Remarks

Claims 1, 3 and 5 have been amended. Claims 2, 4, 6 and 7 have been cancelled. Claims 1, 3, and 5 are pending.

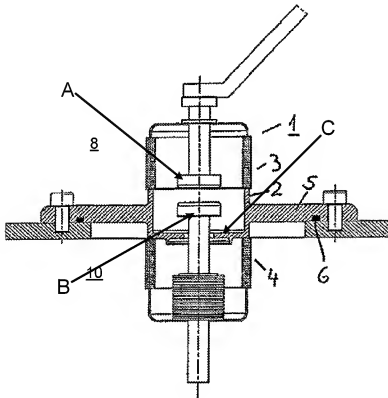
The Examiner rejected claims 1-7 under 35 U.S.C. 112, first paragraph, as failing to comply with the enablement requirement. Specifically, the Examiner asserts that it is unclear what the three operating positions of the vacuum switch are. The Applicant respectfully disagrees with the Examiner.

Three position vacuum chamber switches are well known in the art. Three position switches include a connected position, a disconnected position, and a grounding position. Par 3. With reference to the figure below, it is well known in the art that such switches include a stationary contact (A) and a moving contact (B). The moving contact is driven up or down by a drive. Par. 3. In this manner, the moving contact (B) may be brought into contact with the stationary contact (A), may be brought into contact in the opposite direction with the metallic center part (C) which is grounded, or may be positioned in between, as shown below.

One of ordinary skill in the art would readily understand the above drawing and the operation of the three position vacuum switch without undue experimentation. Accordingly, it is believed that the Examiner's rejections under 35 U.S.C. 112, paragraph one, are believed to be improper.
